ZONING BOARD OF APPEALS

WEDNESDAY August 7, 2024, @ 6:30 P.M.

a. Planning Department report

DRAWING:

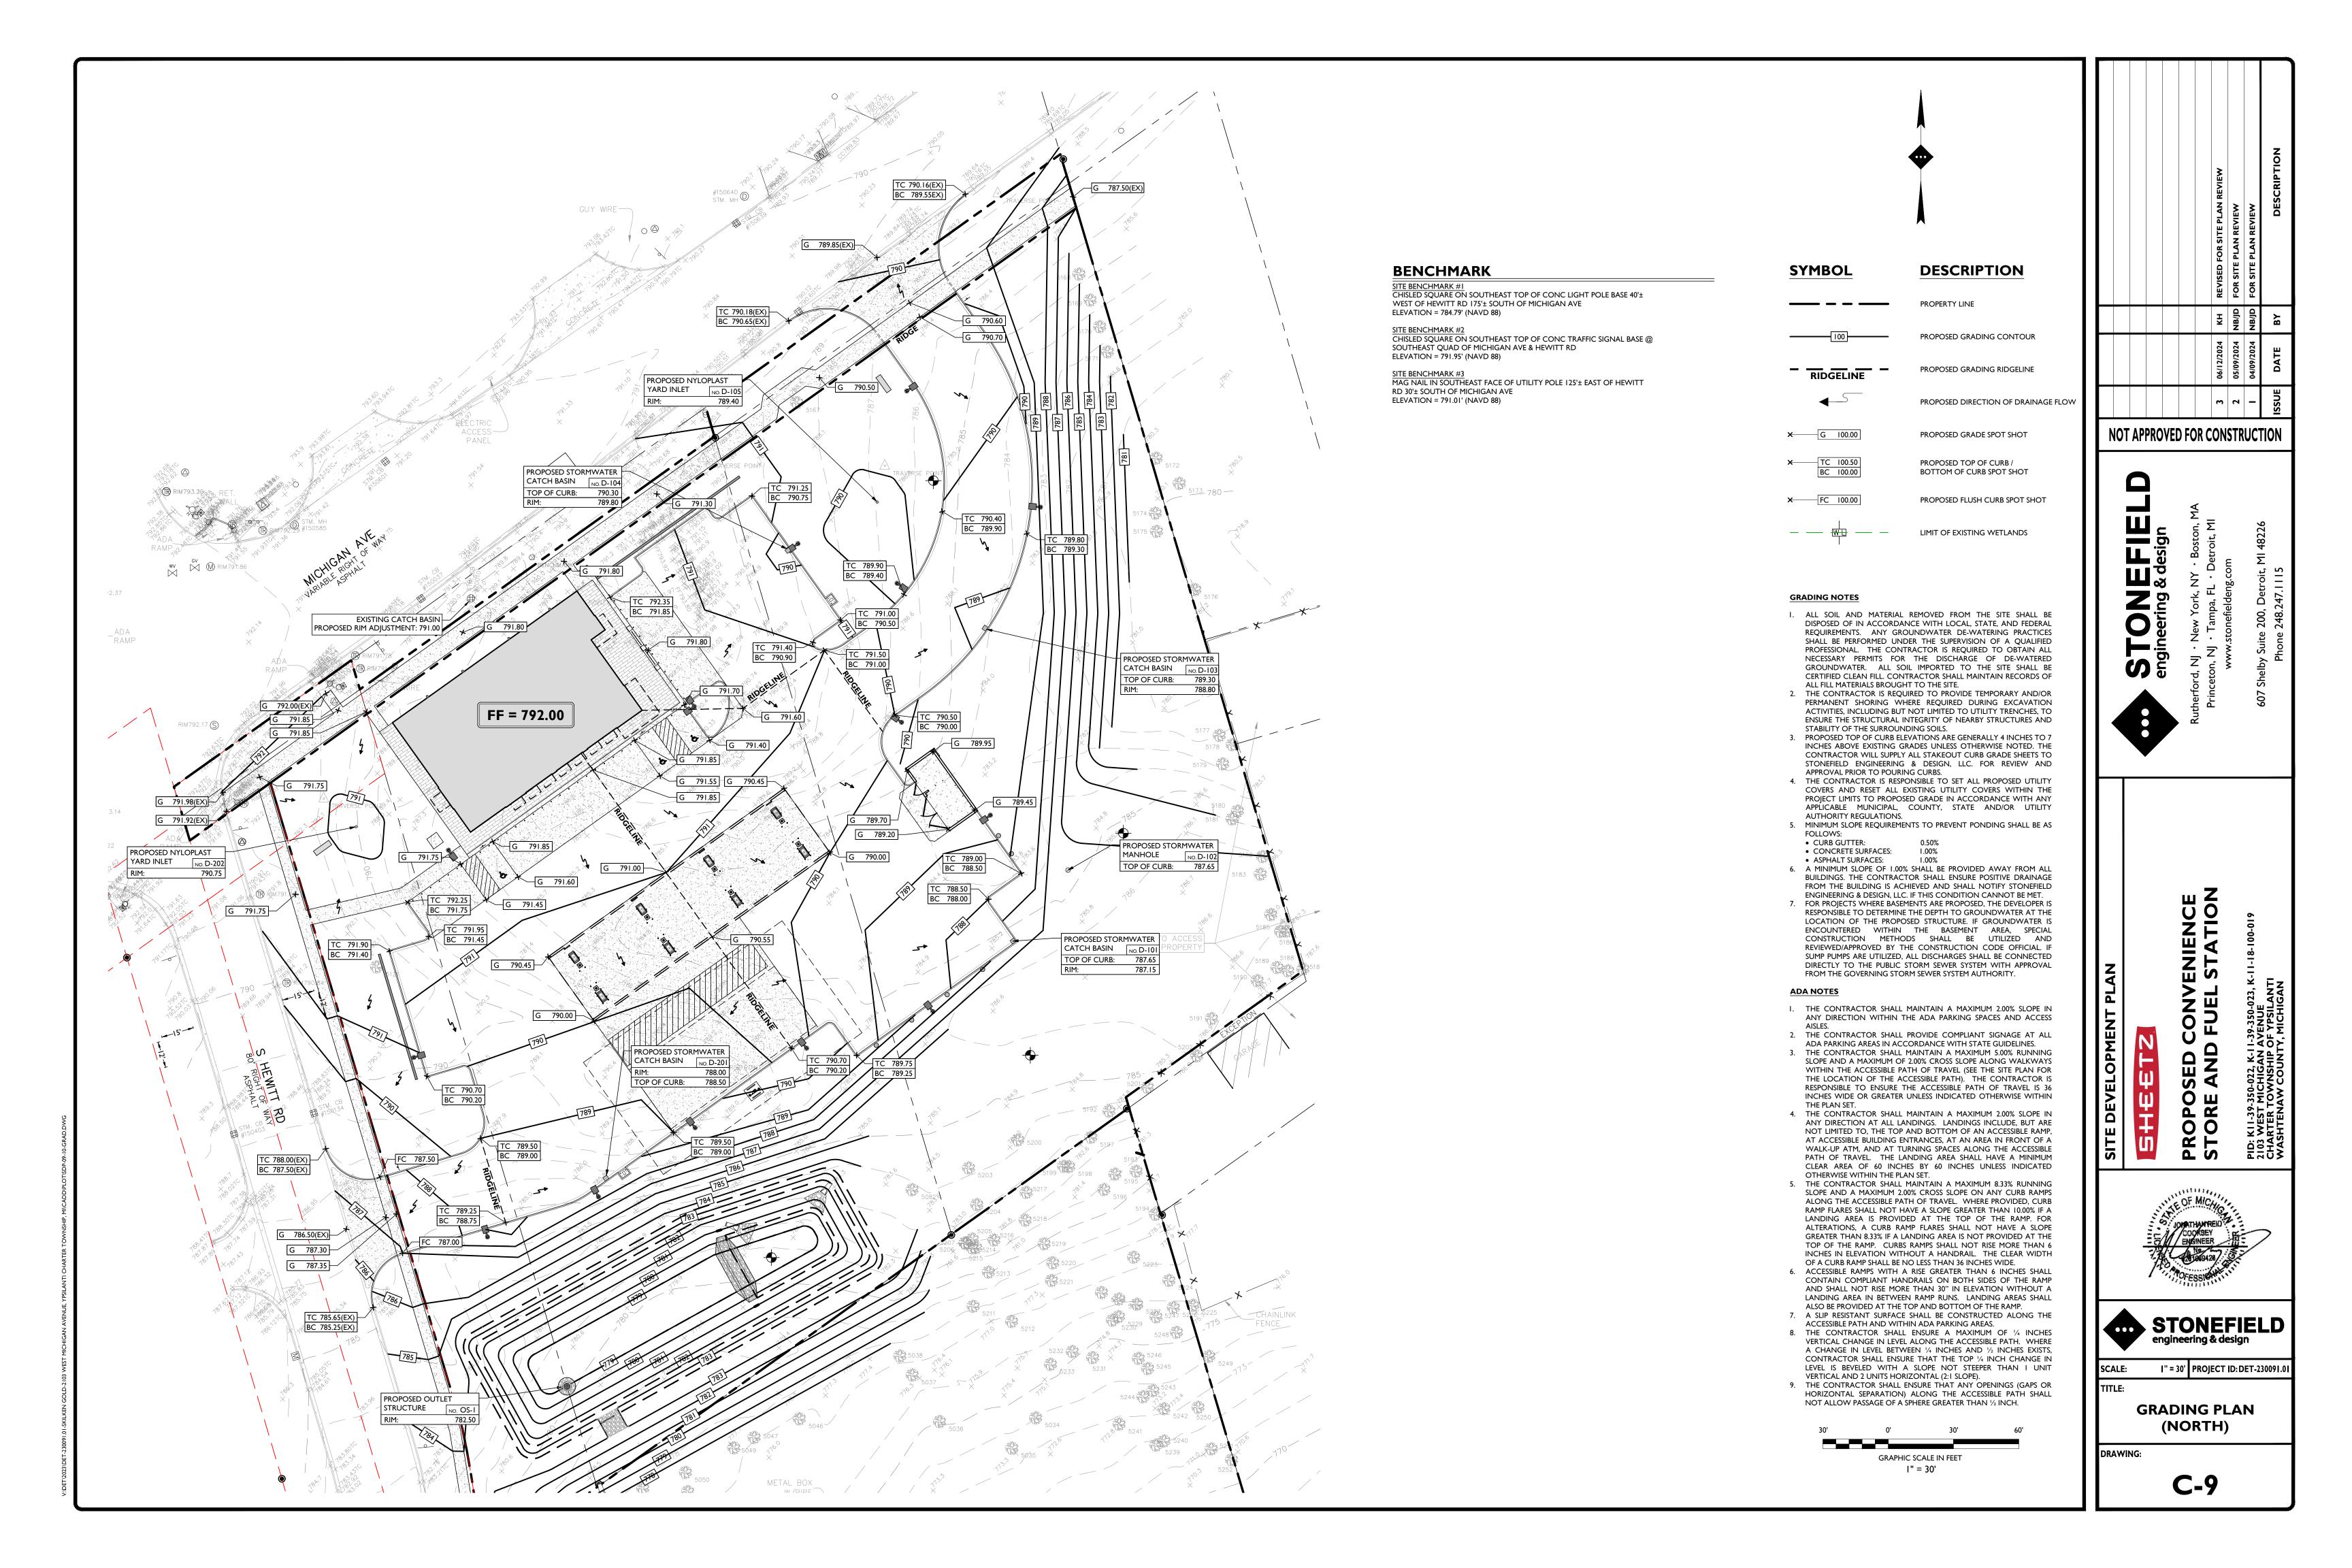
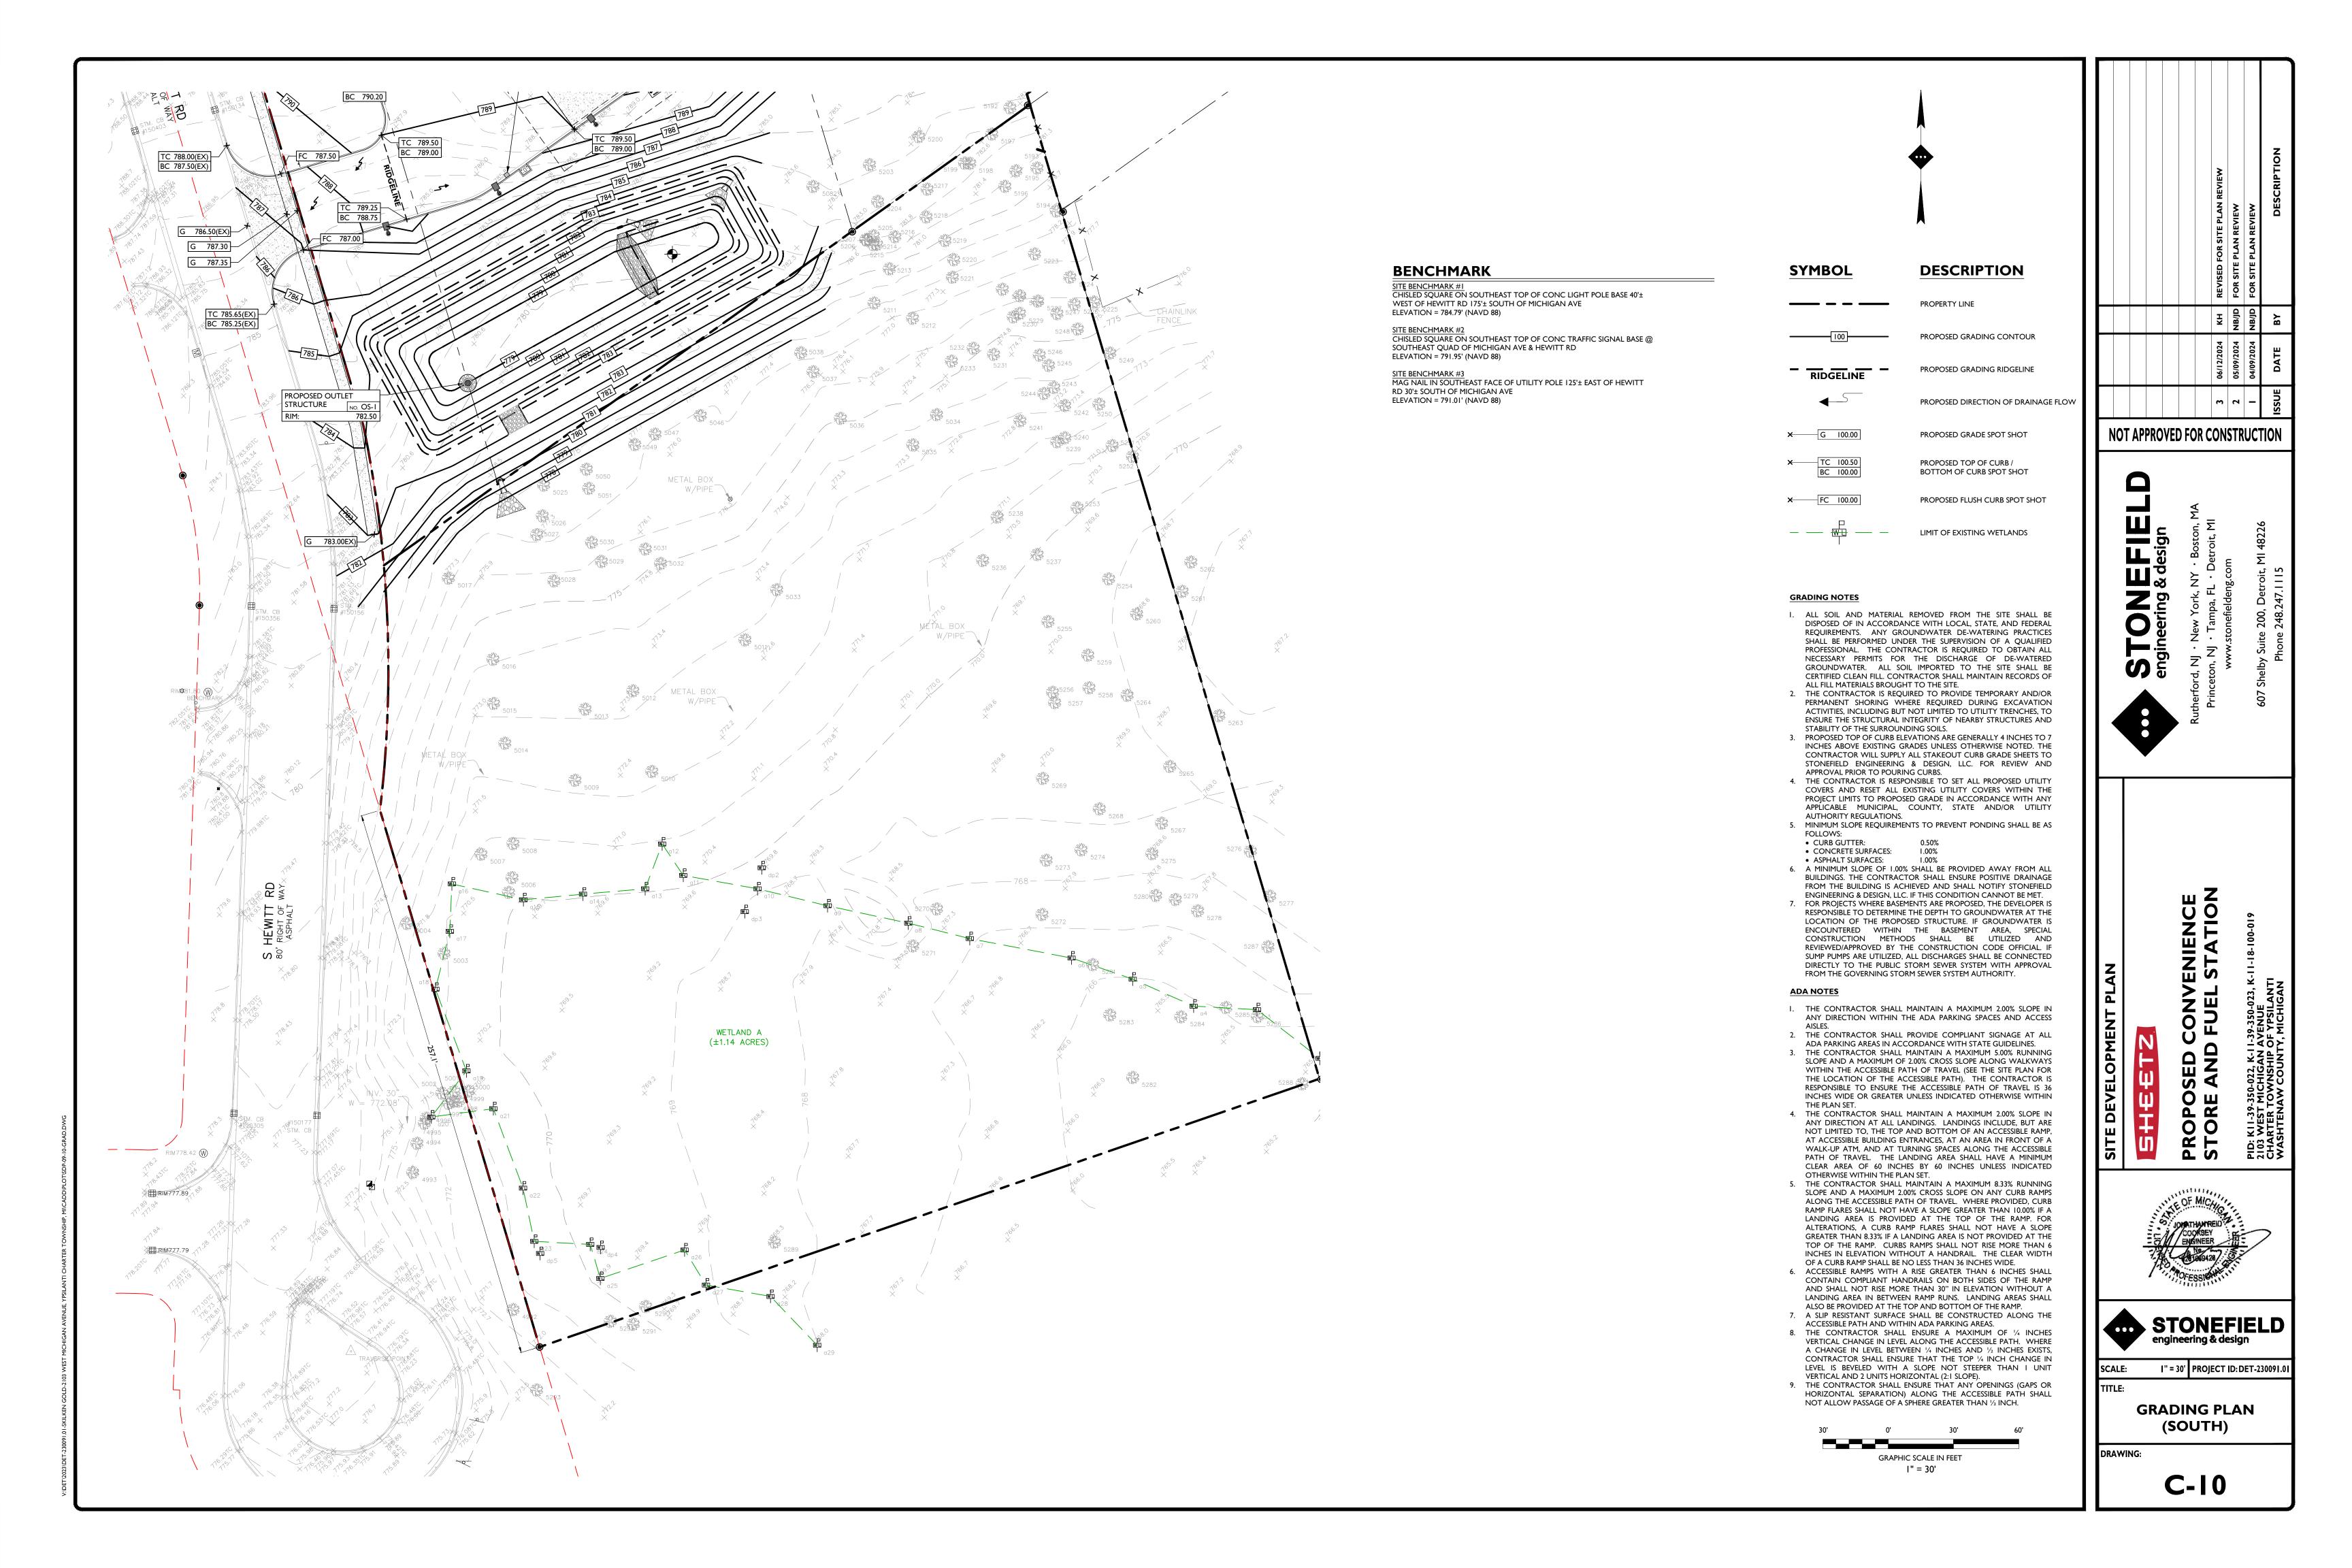
Building Location: The site is occupied by a road easement in the northwest corner, as shown on Sheet C-6. The ordinance requires that the building be placed at the 10-foot build-to-line, which is the line 10-feet from the front property line along a street. Because of this road easement, the building cannot be located 10-feet from the S. Hewitt Rd. property line. Therefore, special circumstances exist on this property that make compliance with the ordinance for building location impossible.

The applicant has not provided any floor plans to show how the interior of the building coordinates with the location of doors and windows. Floor plans should be provided with the variance request to allow the Zoning Board of Appeals to confirm windows/doors would interfere with these facilities.

However, regarding the transparency variance requests, the applicant should provide/respond to the following:

- 1) Floor plans should be provided with the variance request.
- 2) <u>W. Michigan Ave. Transparency Variance</u>. The applicant should respond to the following, and offer other options to increase the transparency on the W. Michigan Ave. façade:

- c. Has the applicant considered allowing customers to view the activity in the food preparation area?
 - d. Would it be possible to add a pedestrian door on the W. Michigan Ave. side of the building?

- 3) <u>S. Hewitt St. Transparency Variance</u>. ZBA and applicant to discuss flipping the orientation of the building, and locating the patio (with the associated window/door configuration) on the west side of the building, facing S. Hewitt. Benefits this could provide include:
